Access Compliance Report Public Rights-of-Way (Curb Ramps)

Main Street: **ELMORE_WAY** Cross Street: **JACKSON_ST** Location: **NW**

ADA ID: **RPRK211005142142** Ramp Type: **Type 1 - Perpendicular Diagonal** Initial Pass/Fail: **Fail** Overall Compliance: **No** Severity Score: **32**

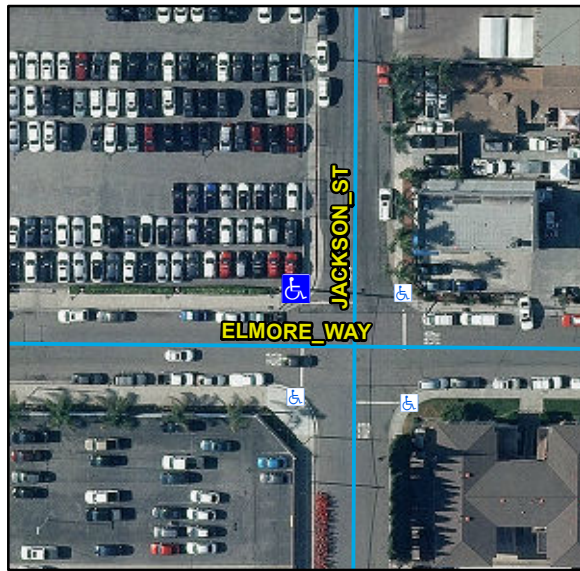
R304.2.2, R304.5.3, R302.7.2, STD 1115

Compliance	Description	Data	Compliance	Description	Data
N/A	Ramp Length (in)	88	N/A	Flare Type LT	
Yes	Ramp Width (in)	48			N/A
No	Ramp Run Slope (%)	13.4	N/A	Flare Slope LT (%)	N/A
No	Ramp Cross Slope (%)	2.8	N/A	Flare Traversable LT	N/A
N/A	Landing Present	N/A	N/A	Flare Type RT	
N/A	Landing Length (in)	N/A			N/A
N/A	Landing Width (in)	N/A	N/A	Flare Slope RT (%)	N/A
N/A	Landing Run Slope (%)	N/A	N/A	Flare Traversable RT	N/A
N/A	Landing Cross Slope (%)	N/A	N/A	DWS Provided	N/A
N/A	Landing Movement Obstructed?	N/A	N/A	DWS Contrast	N/A
	Landing Movement Type	N/A	N/A	DWS Length (in)	N/A
N/A	Landing Shared	N/A	N/A	DWS Full Width	N/A
N/A	Clear Space	Yes	N/A	DWS Offset Left (in)	N/A
N/A	Clear Space To Crosswalk (in)	N/A	N/A	DWS Offset Right (in)	N/A
N/A	Marked Crosswalk 1	No	N/A	Marked Crosswalk 2	No
	Crossing 1 Direction	S		Crossing 2 Direction	E
	Marked Crosswalk 1 Width (in)	N/A		Marked Crosswalk 2 Width (in)	N/A

N/A	Ramp Inside Crosswalk 1	N/A	Yes	Ramp Inside Crosswalk 2	N/A
	Crossing 1 Slope (%)	6.4		Crossing 2 Slope (%)	3
	Crossing 1 Cross Slope (%)	0.8		Crossing 2 Cross Slope (%)	4.2
N/A	Gutter Ponding	N/A	N/A	Curb Slope	4.6
No	Gutter Lip Height (in)	0.5		Road Run Slope (%)	3.1
N/A	Gutter Run Slope (%)	N/A		Road Cross Slope (%)	2.3
N/A	Gutter Cross Slope (%)	N/A			
Yes	Overall Surface Condition: Acceptable		Yes	Perp Joint Present	Yes
	Cross Gutter Present?	No		Spandrel Present?	No
	Replace Cross Gutter?	N/A		Replace Spandrel?	N/A

Remove & Replace Curb Ramp With Two New Directional Ramps or Equivalent. Grind Gutter Lip.
